EBC Ref: F/25/100141 – Kings Copse Avenue: Transport Assessment Addendum

Ref: OT/ITS19785-019
Date: 12 December 2025

- 1.1 This Transport Assessment Addendum (TAA) has been prepared to address comments raised by Hampshire County Council (HCC) in their response (*ref: 058151*) to the Transport Assessment submitted as part of the full planning application for 192 dwellings on Land South East of Kings Copse Avenue (*ref: F/25/100141*).
- 1.2 The comments raised by HCC are included as **Appendix A** and have been grouped into three categories as follows:
- 1 Vehicle Access
 - 2 Pedestrian and Cycle Access
 - 3 Internal Layout
- 1.3 The TAA responds to queries raised by HCC in turn in each category. It is noted that the response from HCC reviewed and raised no objection to the traffic impact (i.e. trip generation / distribution / junction modelling) of the proposed development and therefore no additional information has been provided regarding this element.

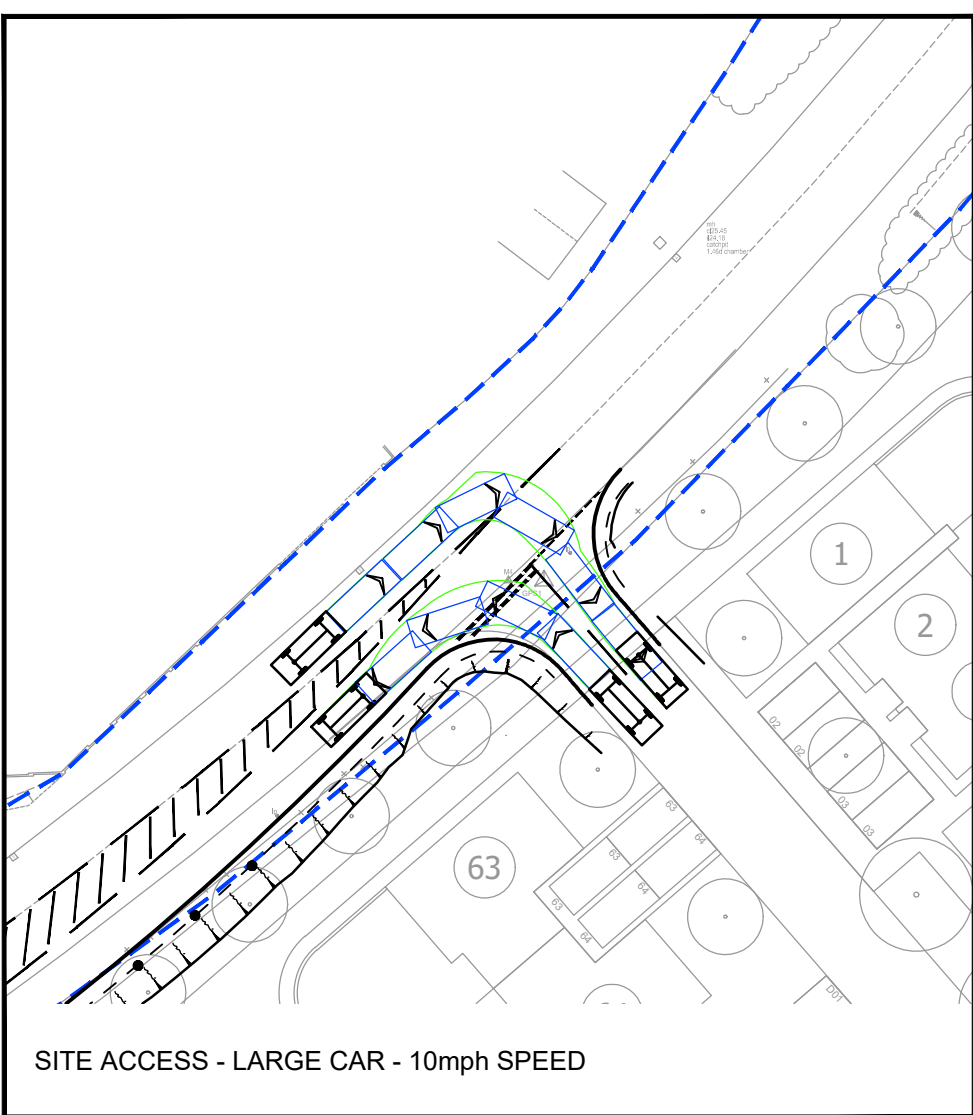
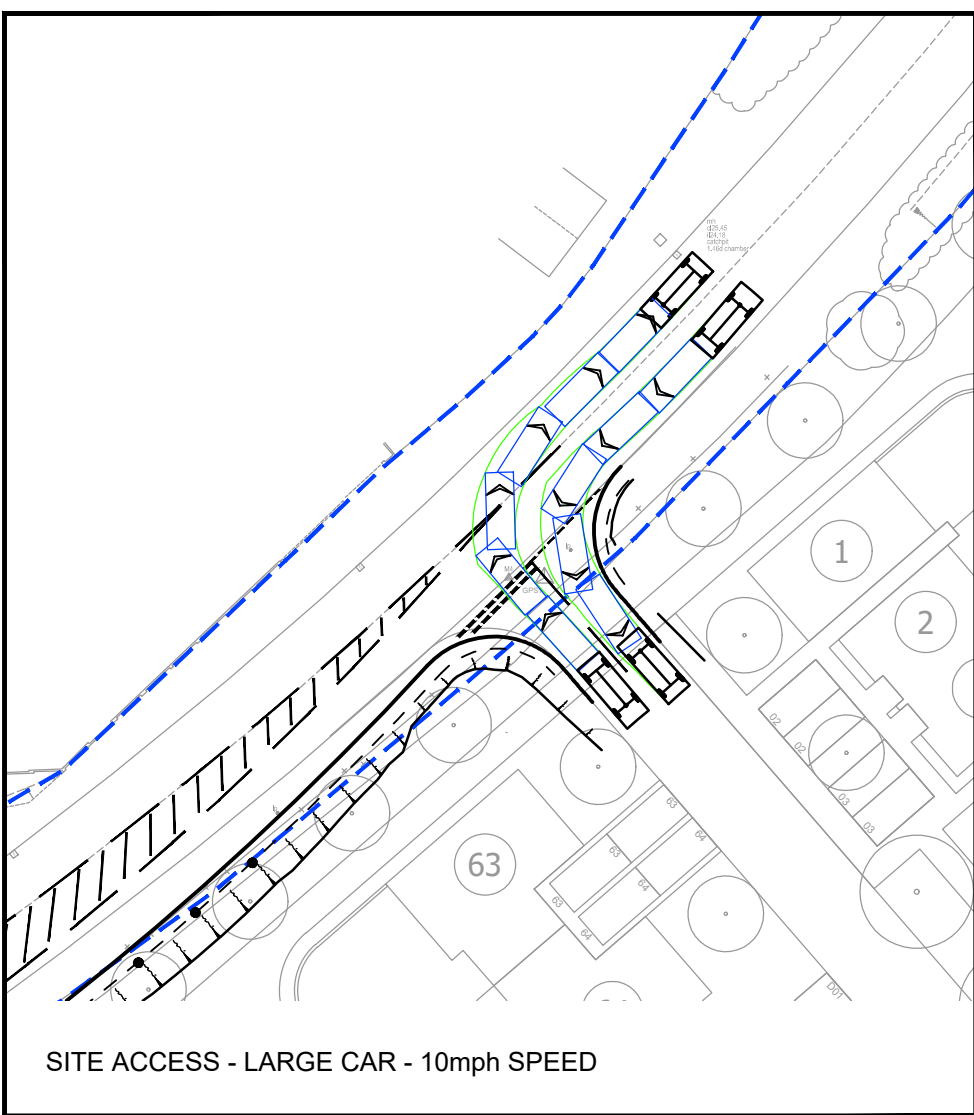
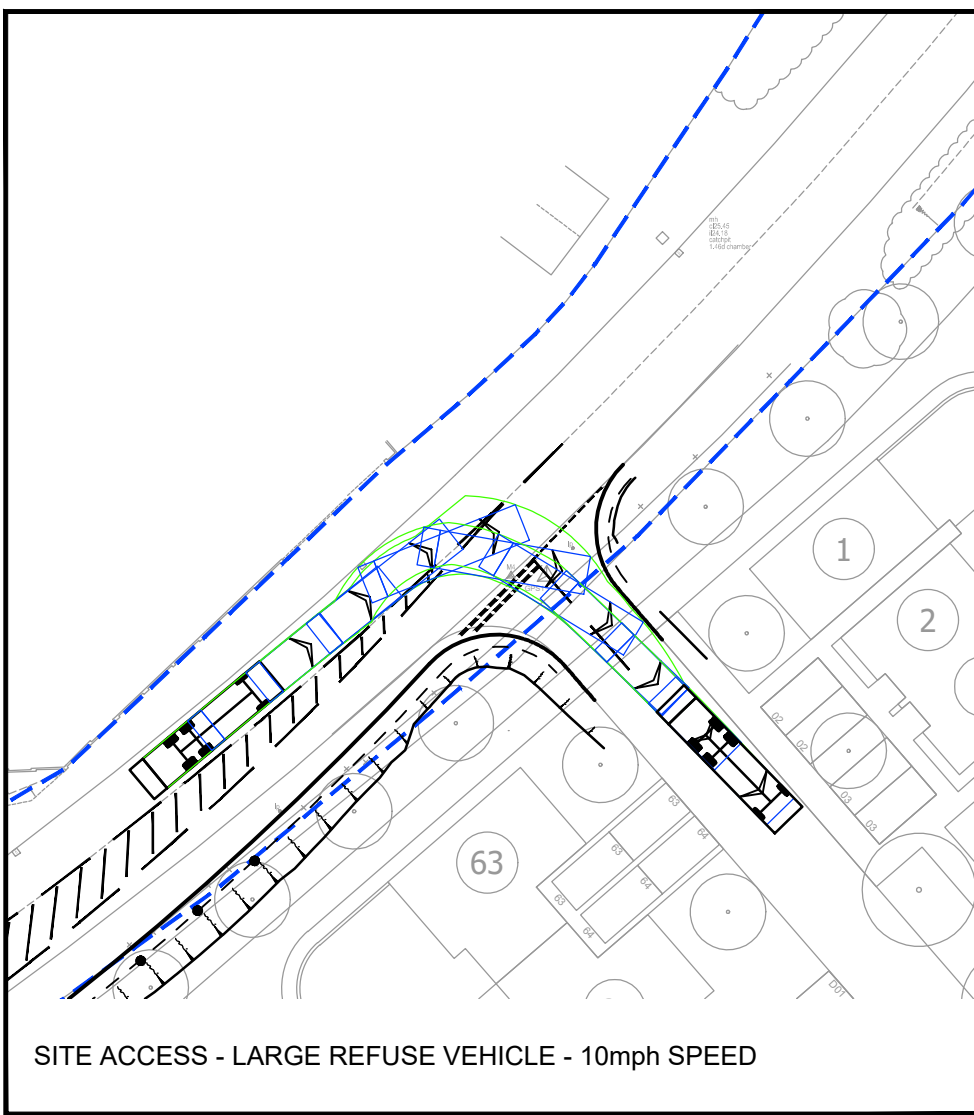
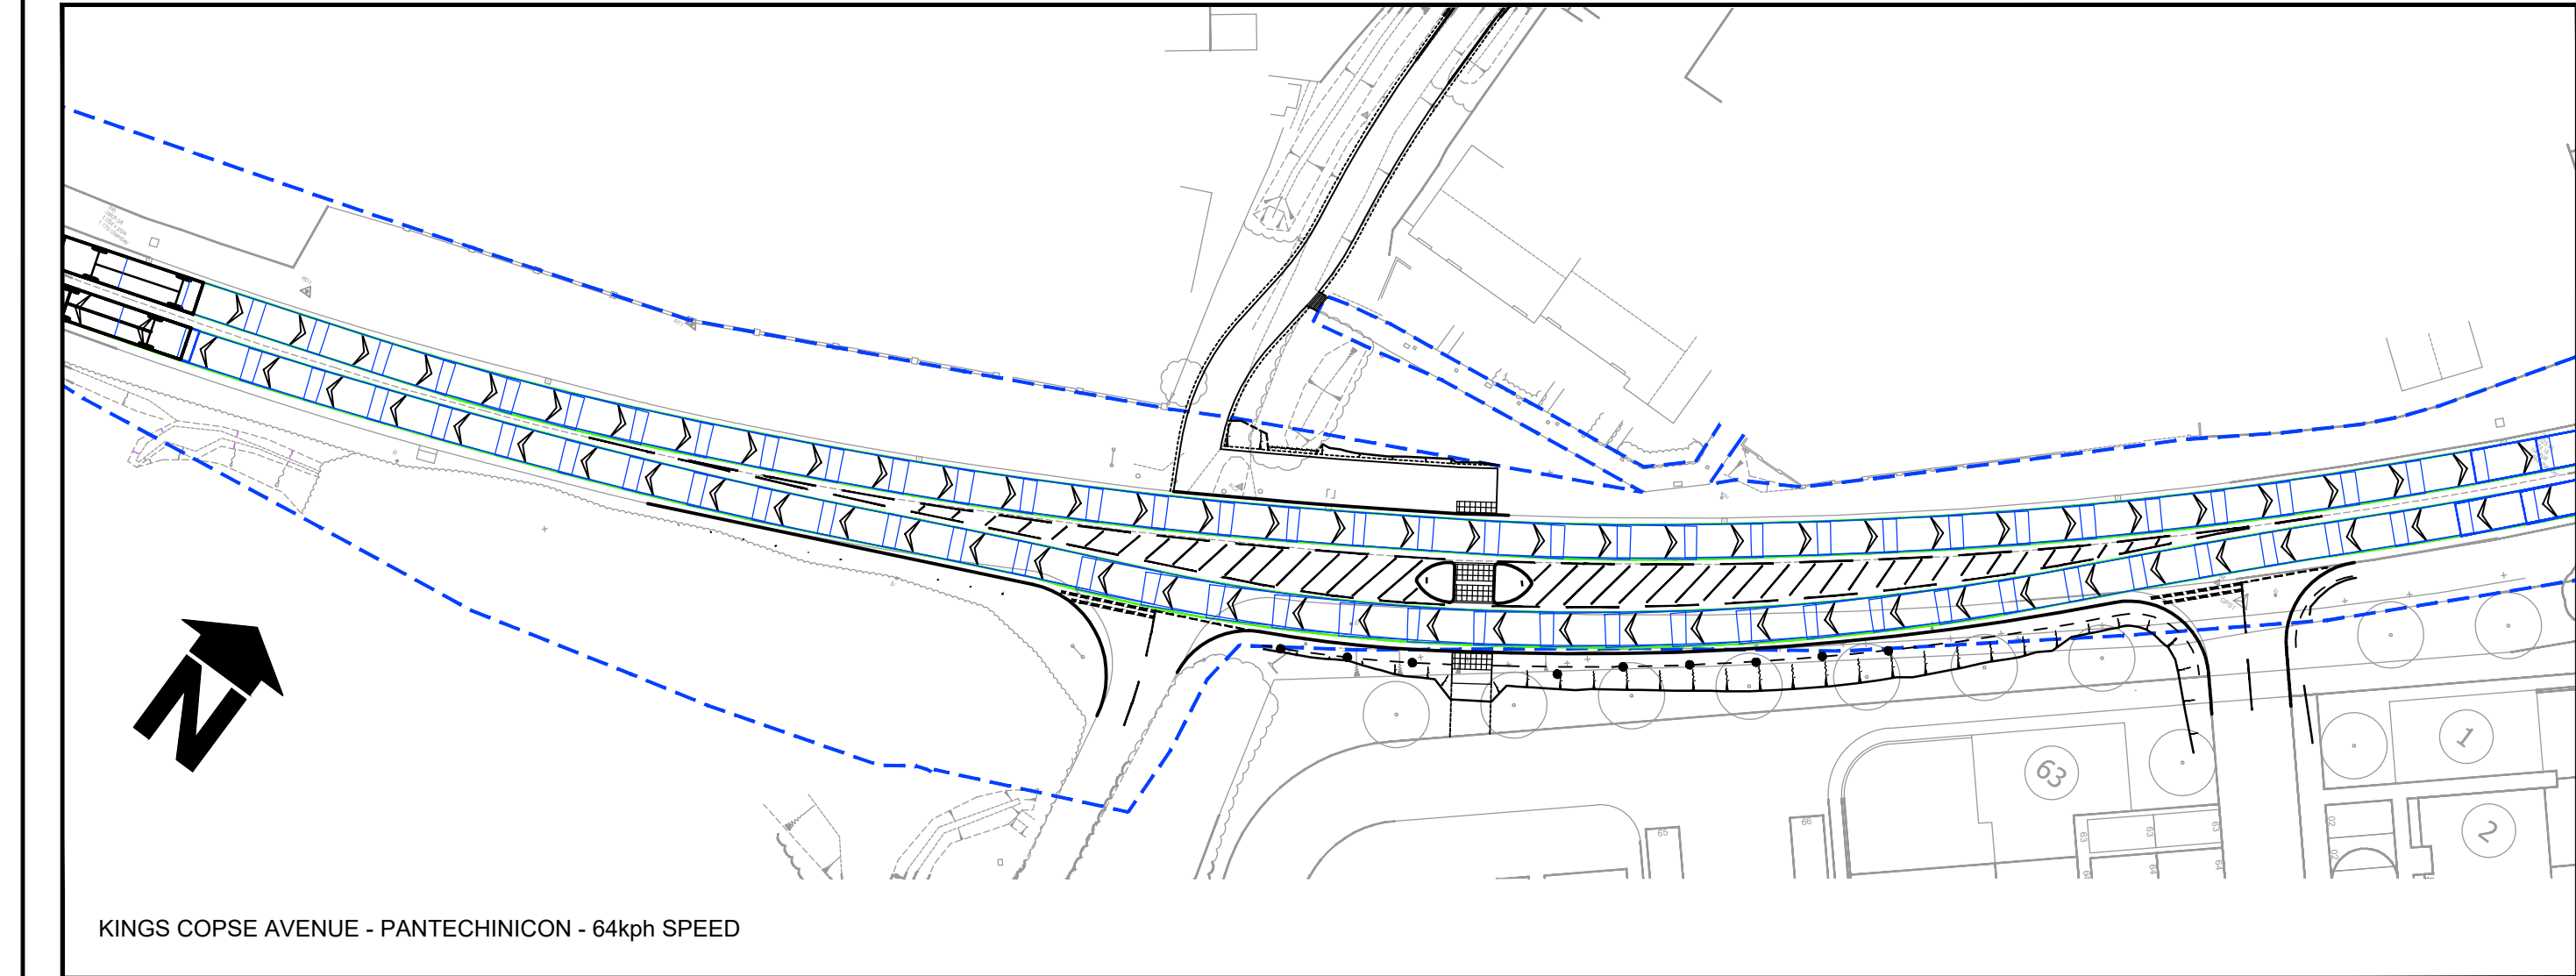
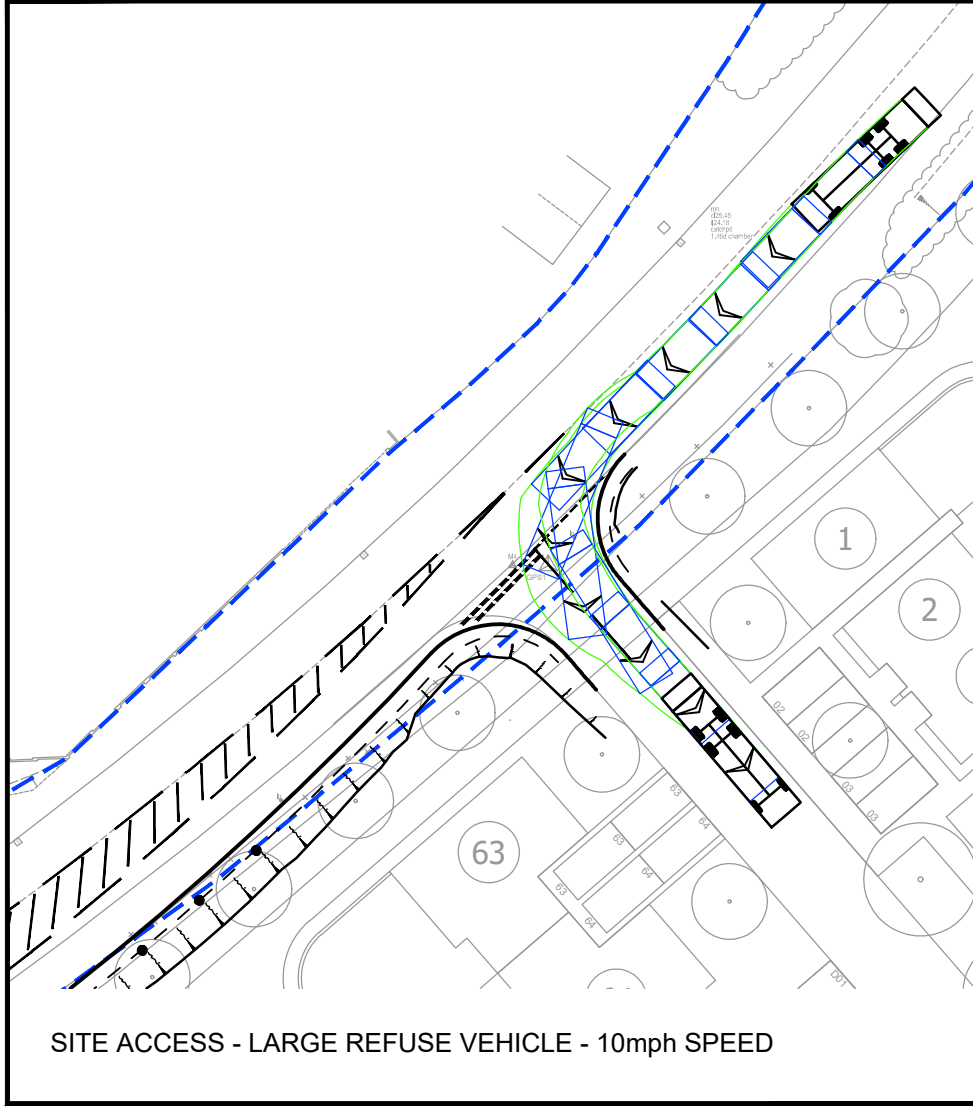
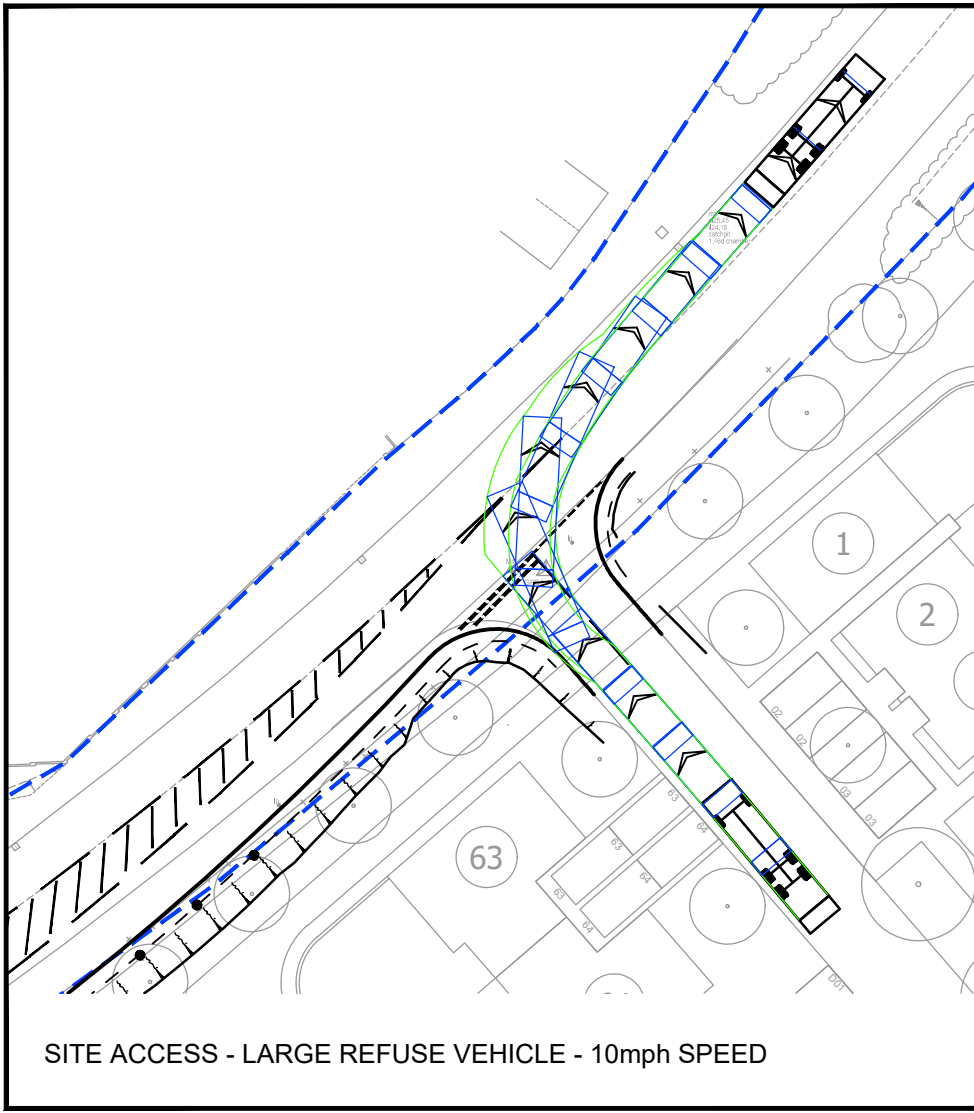
- 2.2.1 HCC have requested that the following swept path analysis scenarios are provided for the proposed access arrangements:

- Fire Tender: Right turn in, right / left turn out.
- Refuse Vehicle: Right / left turn out.
- Large Car: Two-way tracking for all moves.

It is however noted that the drawings supplied do not show the full range of movements at the access. It is therefore requested that the following are supplied:

- Fire Tender: Right turn in, right turn out, and left turn out;
- Refuse Vehicle: Right turn out and left turn out; and
- Large Car: Two-way vehicle tracking for all moves. At present the tracking is shown for internal movements only.

- 2.2.2 The requested swept path analysis scenarios have been undertaken and are illustrated on drawings (ref: 3743.T01 and 3743.T03) included as **Appendix C**. Safe and suitable access to the site will be provided.
